UNITED STATES PATENT AND TRADEMARK OFFICE

10/626,598

Office Action Summary

DETAILED ACTION

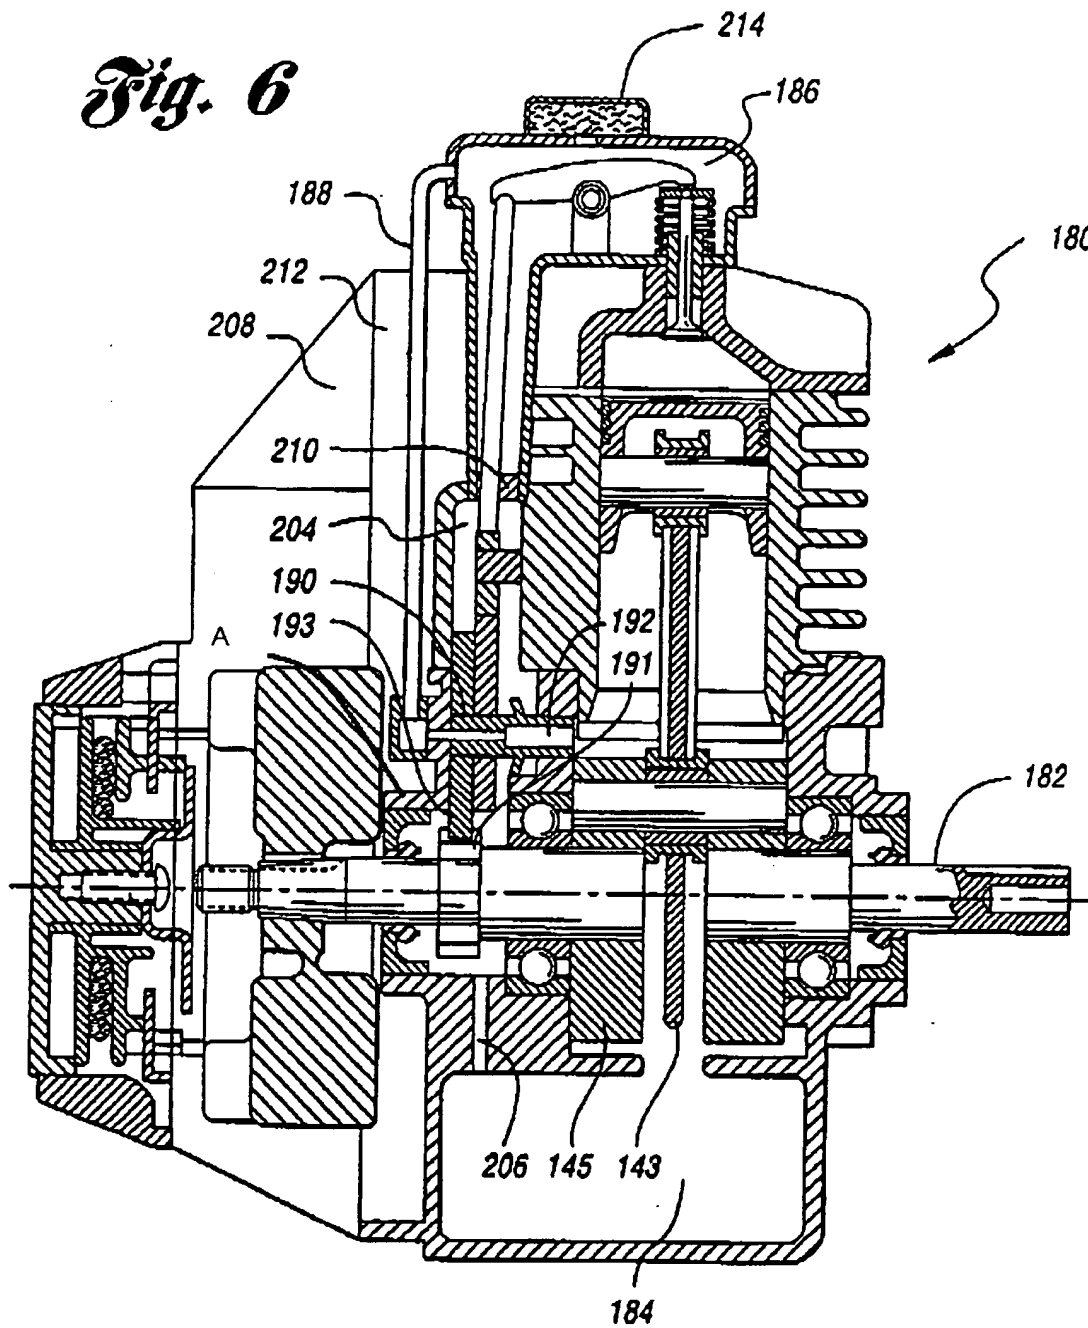
- A common case wall (see fig 6 below, (A))
- A first breather path (196)
- A second breather path (206)
- A third breather path (188)
- A blocking device (190,216)

- Third breather path (188) is formed within a cover wall of a terminal cover (108), and the blocking device (190) is at a joint (see fig 6, joint is

connection between (190) and (193)) between the cover wall and the common case wall (A), comprises an oil return section (see fig 6, oil return section is section of (188) within (212))

- An oil trap (214)
